Garnet Properties Initial Study/Mitigated Negative Declaration Addendum

City of Palm Springs
3200 East Tahquitz Canyon Way
Palm Springs, CA 92262

November 2018

**Garnet Properties Initial Study/
Mitigated Negative Declaration Addendum
Building 1 Elevations
Palm Springs, California**

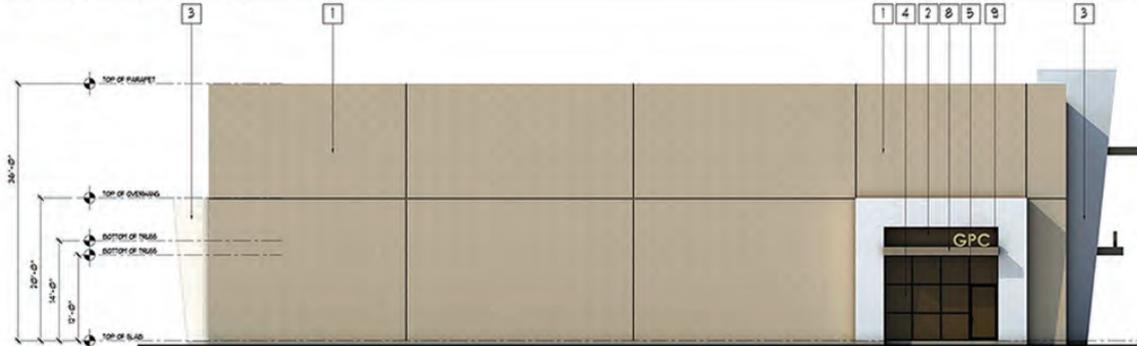
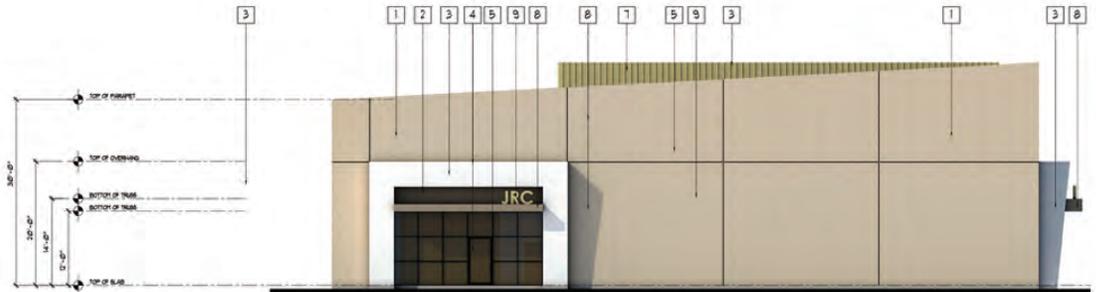
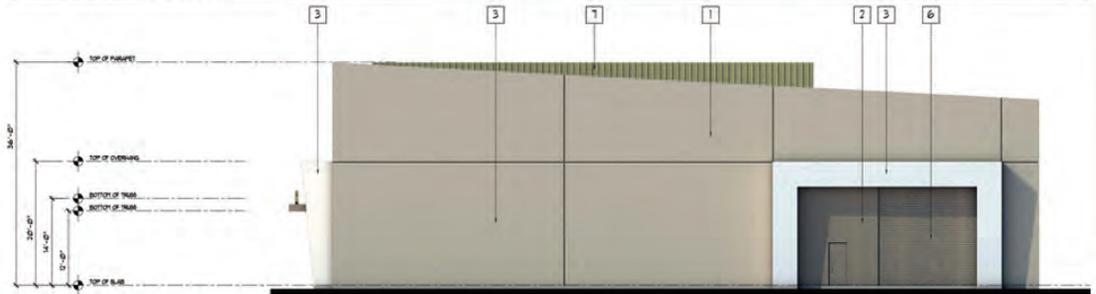
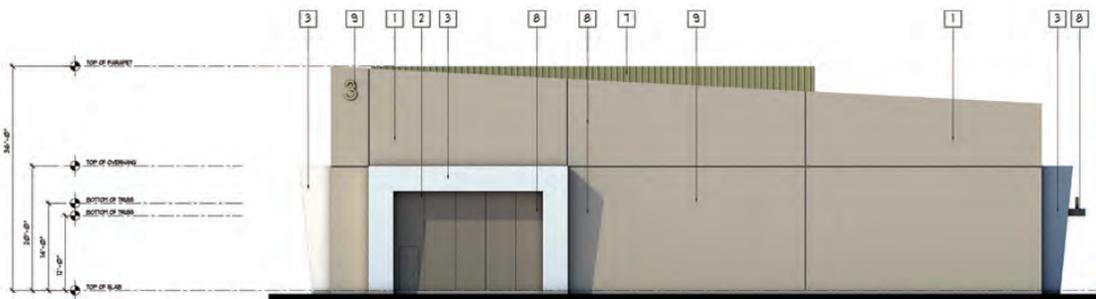
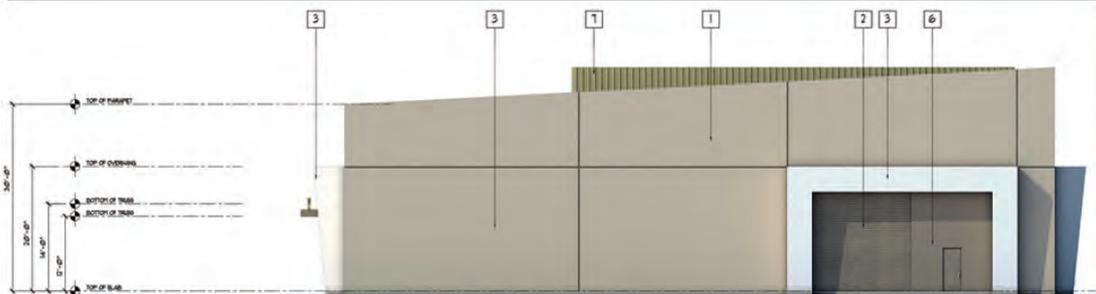
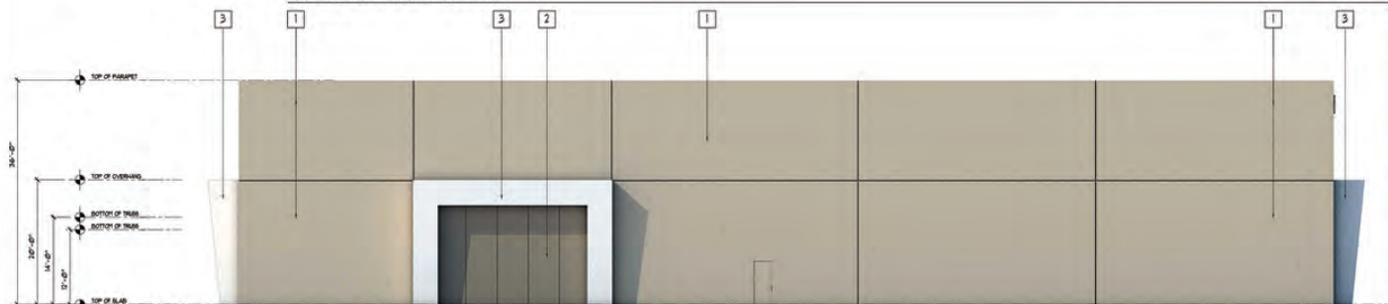
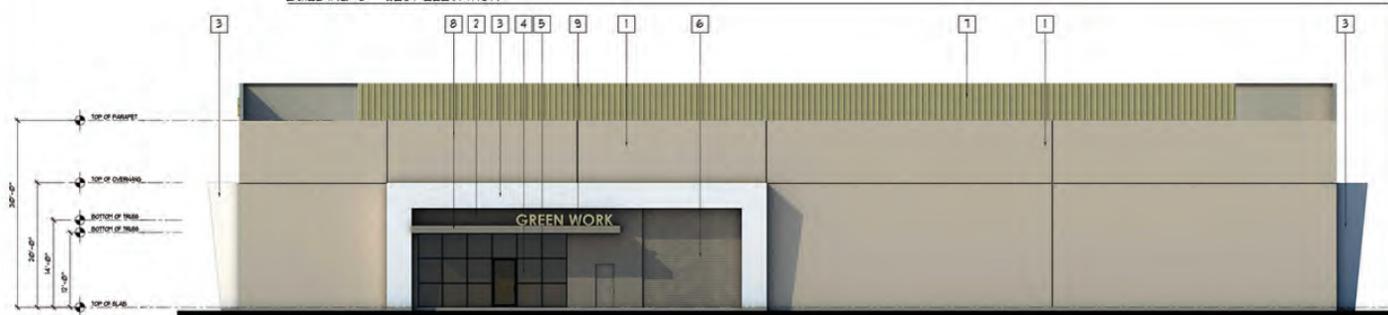
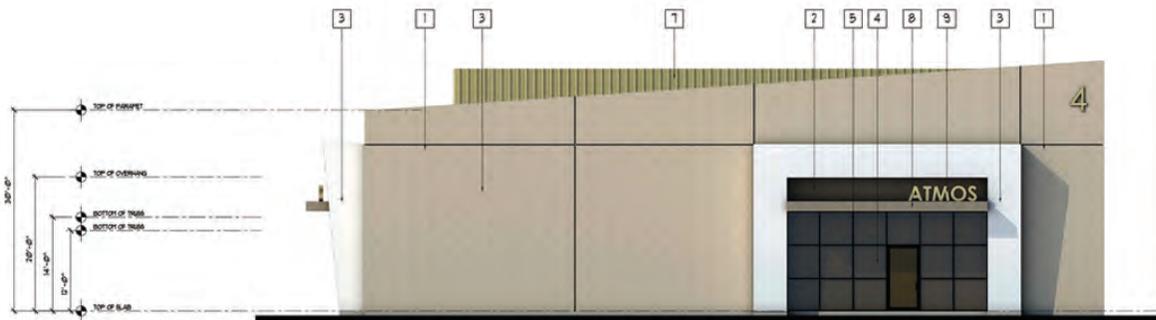
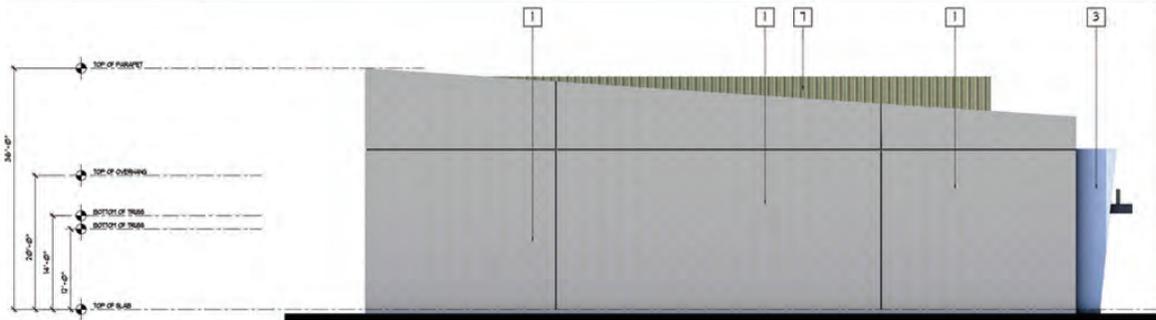
The Revised Project would result in the development of two-story buildings instead of one-story buildings at the site, which would increase the height of the buildings by approximately 6.4 feet. Since the proposed amendments only include an extra story without significant change in the building's layout and material, window glass window panel size, and lighting plan, the light and glare impacts would be the same as what was previously analyzed, and remain less than significant.
